SUNDRY NOTICES AND REPORTS ON WELLS

PROPOSED PROCEDURE FOR PLUG AND ABANDONMENT:

Lusk West Delaware 11
3002534173
Sec. 20 T19S - R32E
1980 PSL & FWL

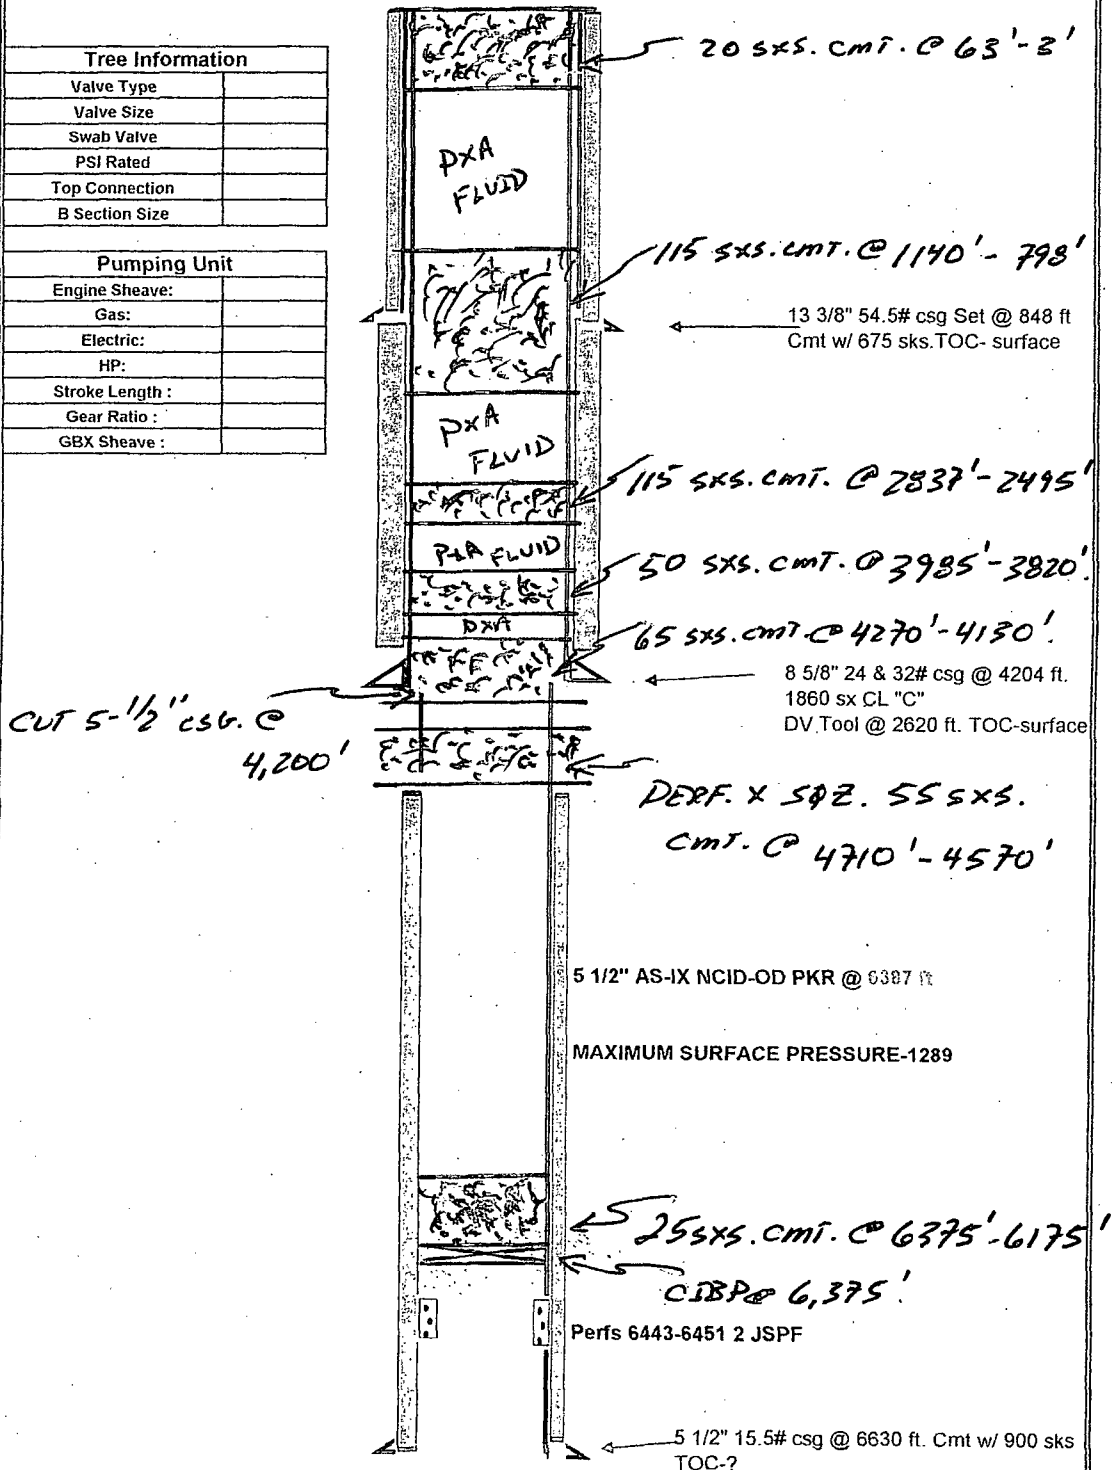
spot 140' plug

combine

spot 140' plug 4254 - 4117 WOC Tag

spot 150' 4710 - 4570

CIBP @ 6175 + 25 sx cont
